Record Number	
Subject:	DA2020/0008 – 3 Central Road, Avalaon
Date:	9 December 2020
From:	Renee Ezzy, Principal Planner
Cc:	Lashta Haidari, Acting Manager Development Assessment
То:	Northern Beaches Local Planning Panel

The following is an addendum to the original assessment report to address the deferred commencement conditions listed in the assessment report.

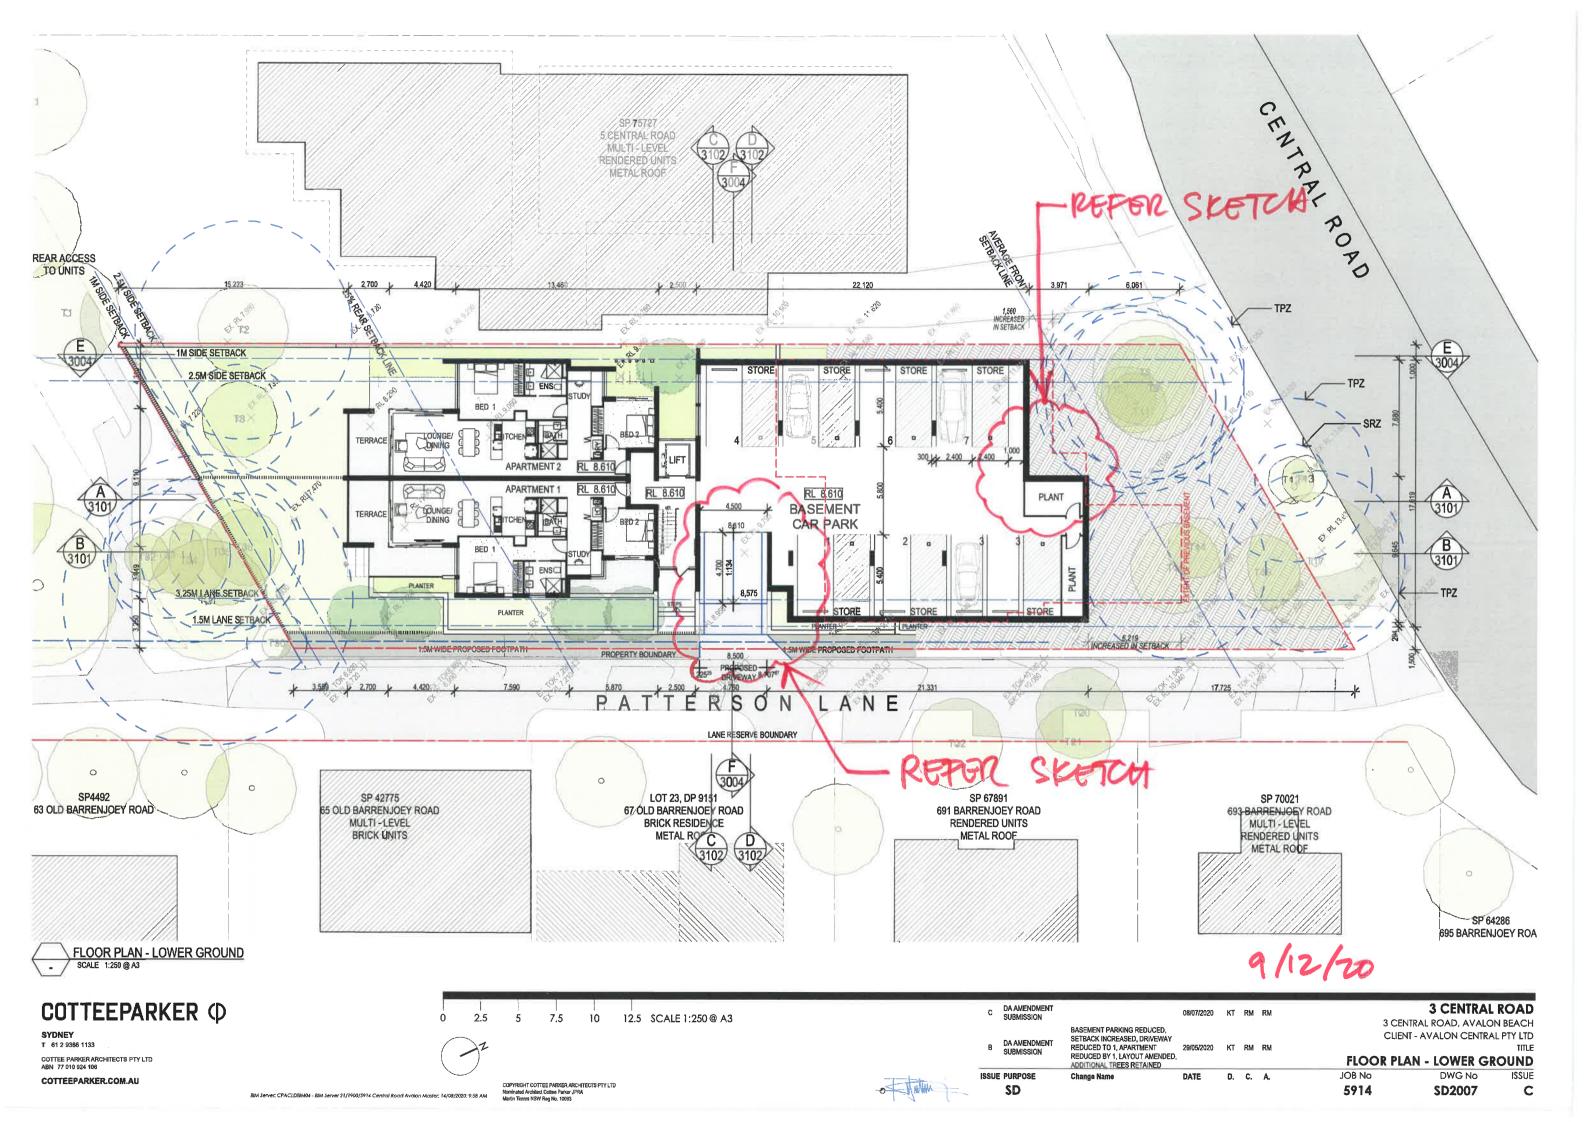
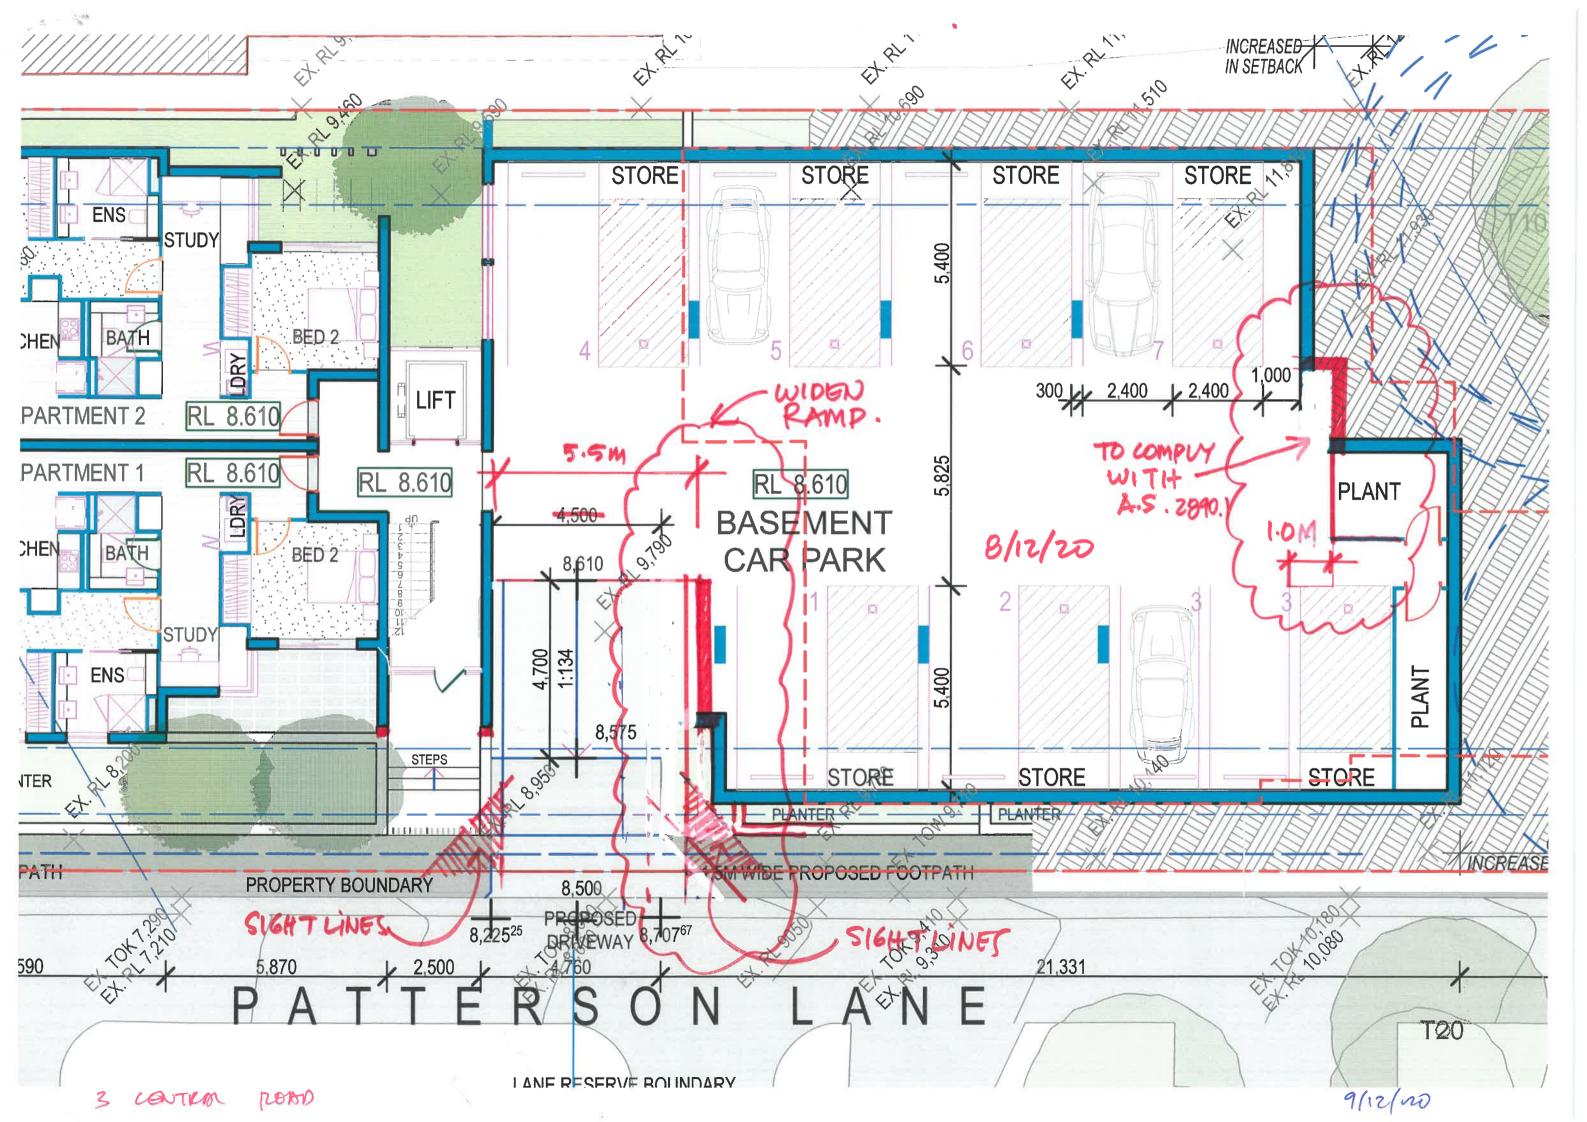
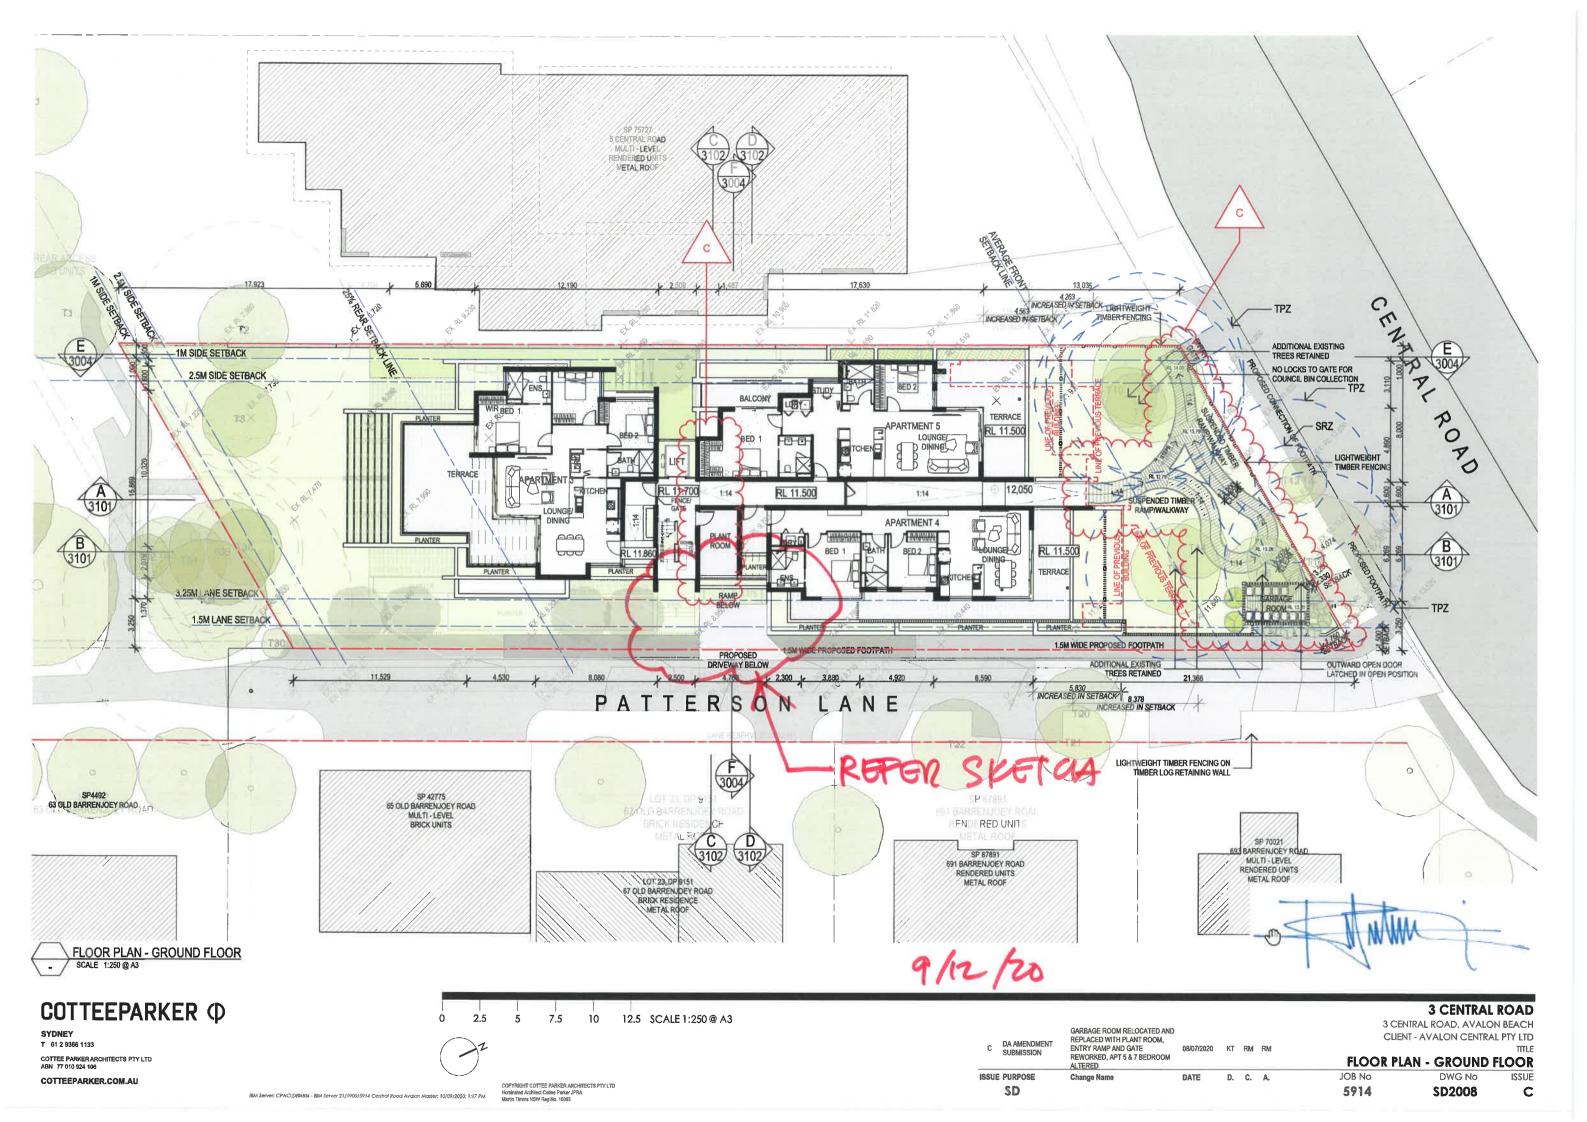
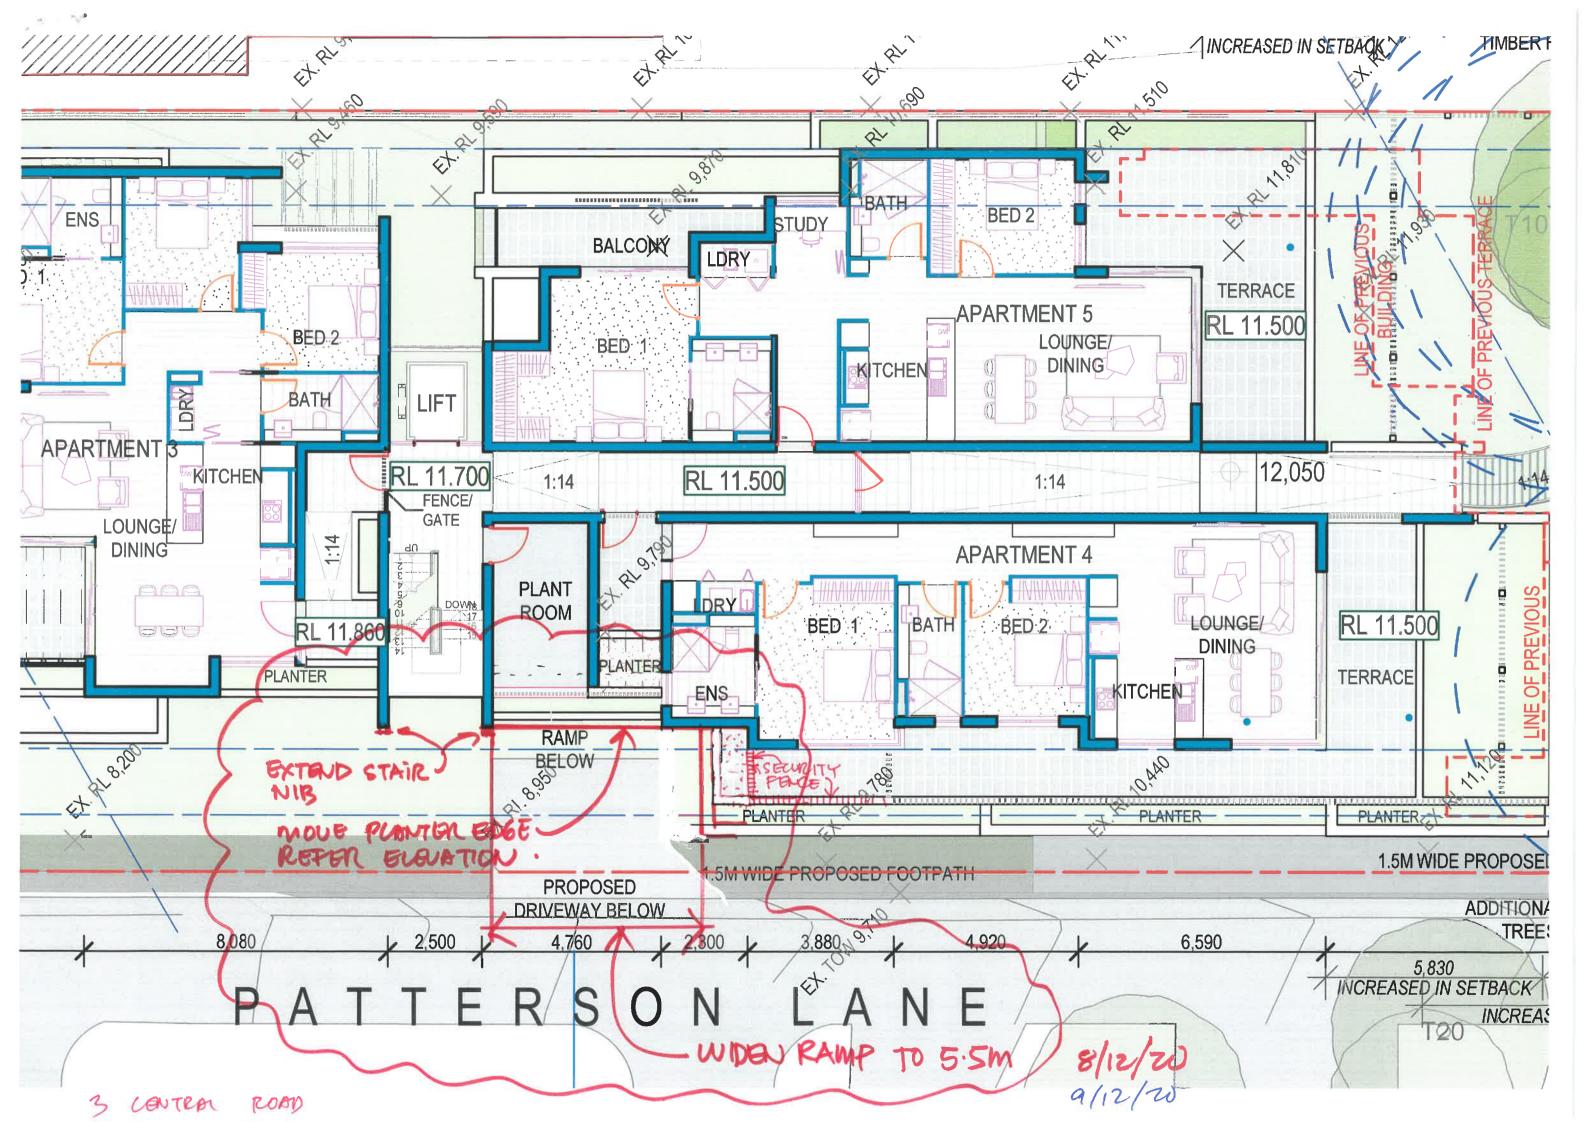
- 3. Impact on vegetation along Patterson Lane and visual impact The proposed tree removal has been thoroughly assessed by Council's Landscape Architect who is now satisfied with the extent of tree removal and replacement planting.

The amended proposal requires the removal of 9 trees within the Patterson Lane frontage. An additional three (3) substantial prescribed trees are retained with the amended proposal which relocated the bin storage area (refer to report under submissions). These trees are within the front setback of the site opposite No.693 Barrenjoey Road.

4. a. *Dimensions of the road widening strip.* The dedication of land will require up to 1.0m of land from the subject site.

b. As this development is completely dependent access from the Lane presumably it is to be dedicated free of charge? The dedication of land and construction of the footpath will be at the developers expense.

c. Impact of patio setback to lane

The setback of the 'patio' to Apartment 4 is more than 17m from the property at No. 693 Barrenjoey Road. The height of this patio is 1.1m from the finished road level at the northern most end.

3 CENTRAL ROAD, AVALON BEACH CLIENT - AVALON CENTRAL PTY LTD TITLE **STREET ELEVATIONS** DWG No

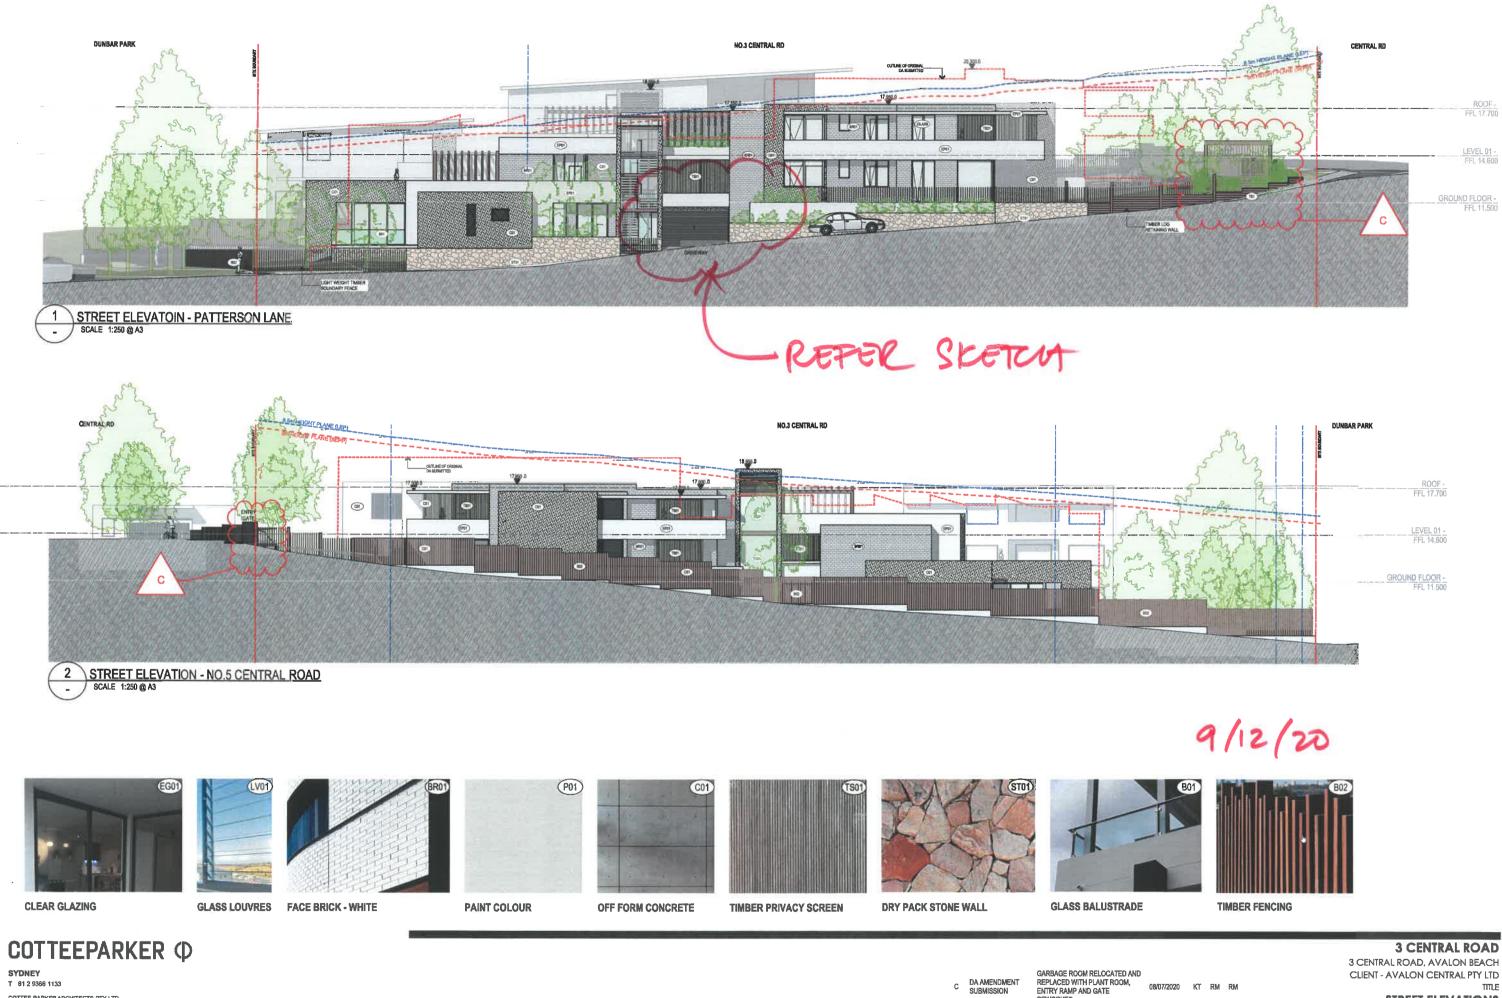
5. Does the carpark work and satisfy the SEPP? The carpark layout as amended to include a splay, wider driveway and 1.0m aisle width to space 3 has been reviewed by Council's Traffic Engineer as acceptable.

An amended plan (attached) has been provided by the Architect to incorporate the requirements of Deferred Commencement Condition 2. The plan provides a widened driveway entry ramp to 5.5M, splay for pedestrian sight lines and extends the dead end aisle adjacent to carspace 3 to 1M to comply with AS2890.1.
